PRODUCT NOTICE

PN630

Models Affected: TLM

SUBJECT: Load Chart

Figure A. Load Chart Location

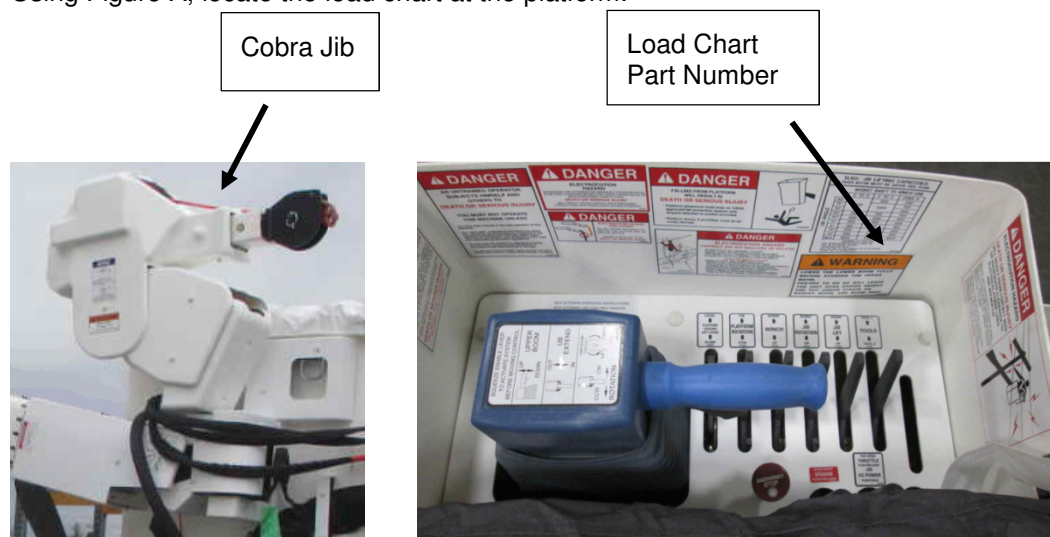
Terex has determined that some aerial devices manufactured from January 2015 through August 2016 may contain an incorrect load chart. **Loading the jib to the maximum capacity could result in a delay in the platform leveling system.**

Using Figure A, locate the load chart at the platform.

Only TLM end mount platform units with a Cobra Jib and a load chart with the following part numbers are subject to this bulletin

Load chart part numbers: 492508, 493014, 494373, 495460, 499778, 604941, 605421, or 605530

- 1) Immediately inspect the load chart according to the inspection procedure below to determine if your unit is subject to this bulletin.
- 2) Replace the load chart with the load chart supplied in the envelope and fill out the completion form if your unit is subject to this bulletin.
